Mendocino County SB844 Jail Project
CP915
951 Low Gap Road35
Ukiah, CA

CHANGE ORDER

CHANGE ORDER NO: 001

Contractor Change Order Request-010 Revised 6/7/24 Value Engineering (see attached).

Proposed VE Option

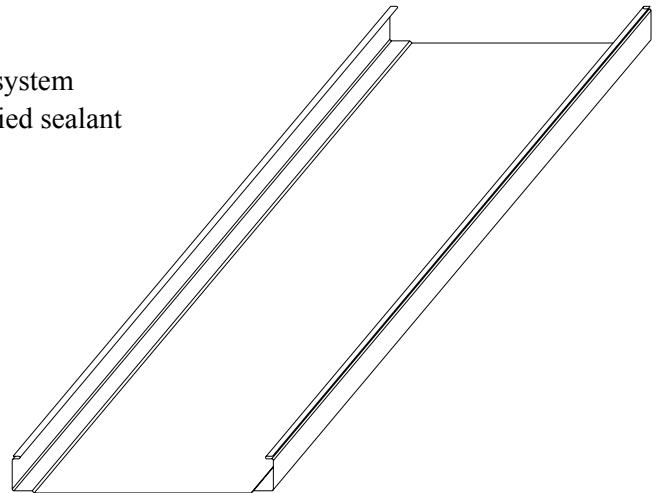
Solano County Roofing has provided pricing for the project per the construction documents with a VE option for the standing seam metal roofing, spec section 07 41 13.16. The VE option consist of similar appearance standing seam metal roofing by a different manufacturer. The proposed manufacturer is Metal Sales out of Woodland CA. The cost for the metal sales roofing is \$93,055. This would be a savings of \$35,638 if the VE option is selected. Please let SCR know if the VE option is something the county would like to move forward with.
